## Proposed Timaru District Plan 2022

### Urban Design Matters

Final: 11<sup>th</sup> April 2024

## Attachment 2

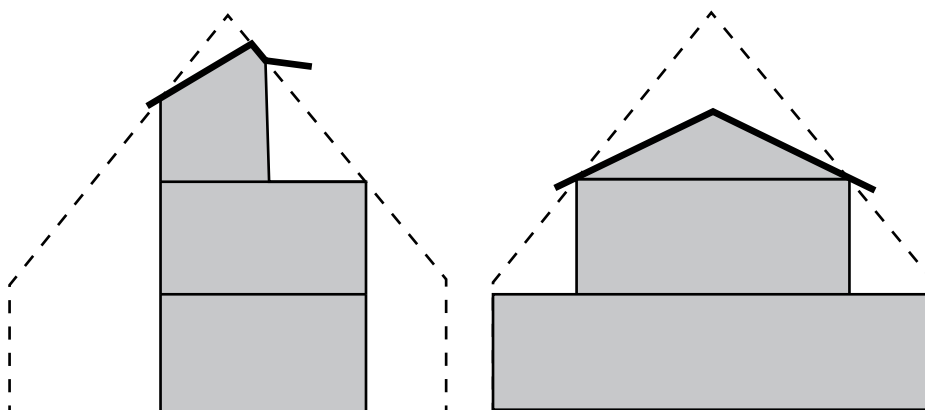
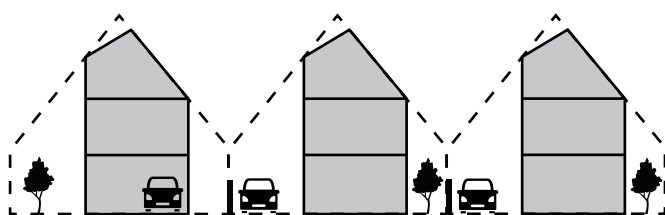
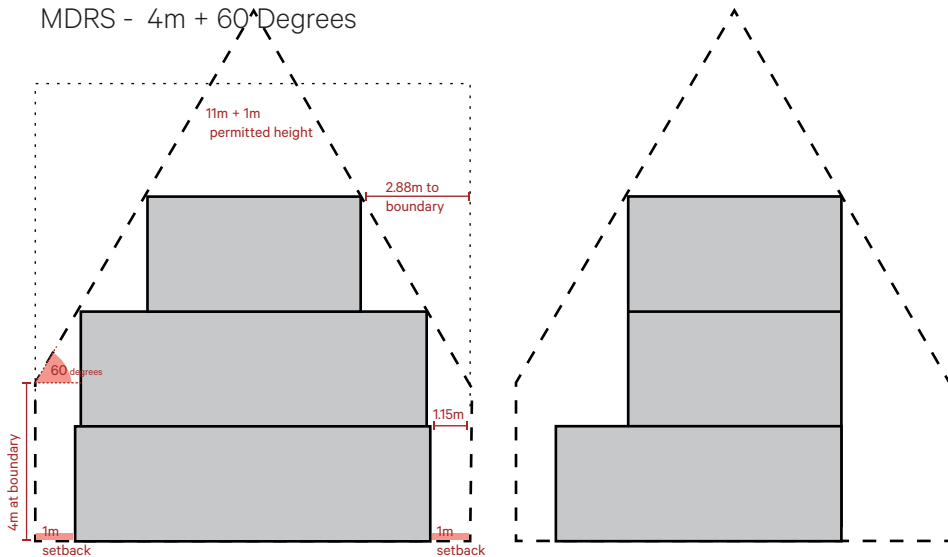
Recession planes apply in the MRZ and in many cases recession planes can result in the setback of buildings from boundaries in order to position buildings efficiently within the envelopes recession planes create. However recession planes are measured from the boundary, therefore there is the ability for buildings to be built up to side and rear boundaries at ground level in the MRZ as these recession planes apply from a height of 3.5m at the boundary (except the front boundary). Of note they apply from a height of 2.5m in the GRZ, which is a height that does not allow for the establishment of a ground floor or single level building.

Given the above, gaps between buildings would be better for daylight entry, space between buildings for access and landscape planting (refer Attachment 2). The only exception to this would be for integrated multi-unit medium density housing schemes

- MRZ Permitted Height: If 3 storeys is the intended built outcome, then an 11m permitted height standard is recommended or if increased height is desirable for roof articulation but not additional storey heights then a 12m permitted building height could be used but must be associated with roof pitch angle controls.
- MRZ Building Setbacks: I recommend setbacks be introduced. These could be the MDRS setbacks of 1.5m front yard setback and 1m side yard setbacks. I also suggest in conjunction with setback standards in the MRZ that assessment criteria relating to infringements to setback standards should enable integrated, multi-unit medium density developments to be built to side boundaries where other on-site amenity and streetscape character are still achieved.

### Attachment 3

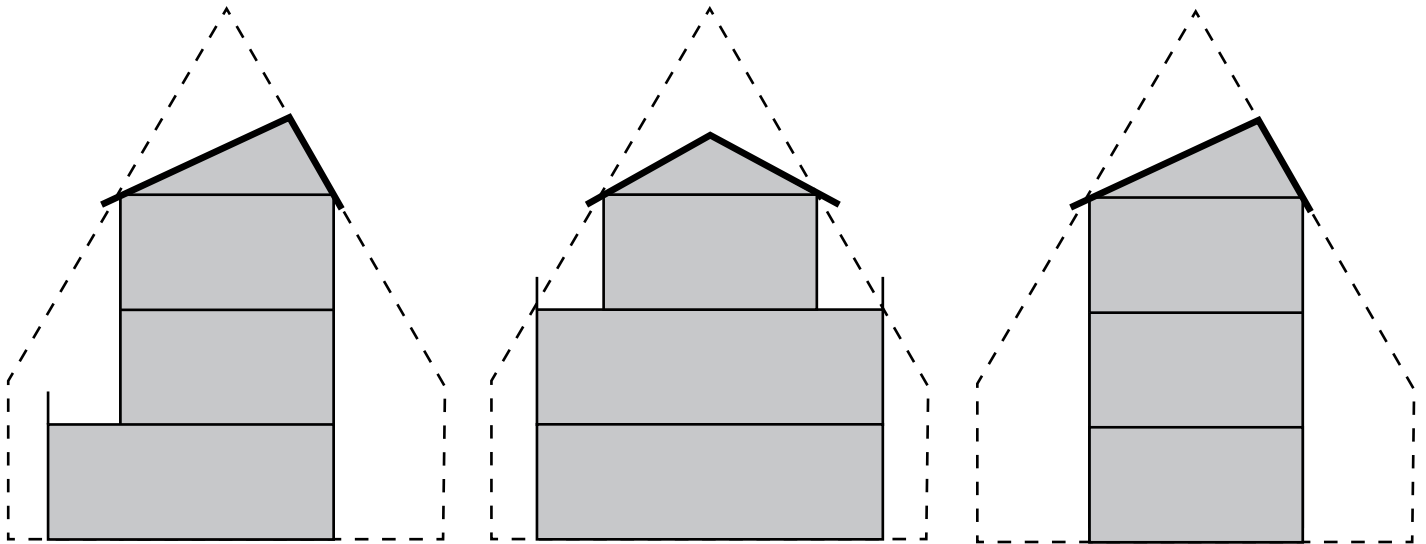
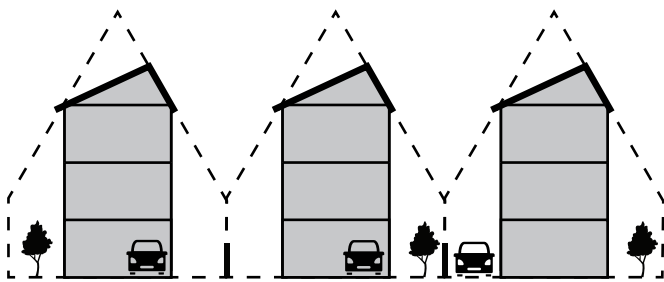
where terraced housing or zero-lot housing/duplexes could be created that shared building walls at the boundary through a comprehensive design approach. The MDRS includes a recession plane of 4m +60 degrees along with a 1m setback, which then avoids the possibility of buildings being built up to the boundary at ground level. I consider a similar approach that includes setbacks to be suitable for the MRZ (refer Attachment 3).

## Attachment 5

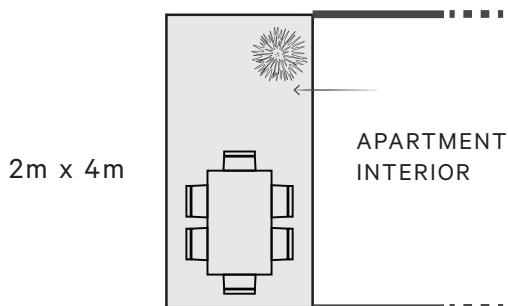
Stafford Street does appear as a mainstreet with 'two halves'. The George Street intersection is where retail continuity and pedestrian activity is currently observed to reduce along Stafford Street, when travelling southwards. South of George Street currently has less retail frontage, more vacancies, gaps in a consistent building edge to the street and generally less street vitality (refer Attachment 5 for photos of current Stafford Street characteristics).

At present, I do not think an alternative to the current retail environment has been expressed in this way that is also supported by a suite of standards and/or design guidance. As a result I consider it is suitable to treat Stafford Street consistently across its full length until such a time an alternative outcome has been fully developed for inclusion into the PDP (potentially by way of subsequent plan change). This includes the consistent application of verandah and active frontage controls along its length. Should residential activity at ground floor be desired that results in infringements to active frontage and verandah controls, the design suitability can be assessed by way of resource consent. It is noted residential above ground floor is permitted in the CCZ.

- Retain CCZ-S3 in its current form, which requires verandahs along all building facades fronting Stafford Street.
- Retain CCZ-S4 in its current form, which requires active frontages within the CCZ. It is anticipated that this standard will still apply even if the Southern Centre Precinct is removed, as requested by submissions.
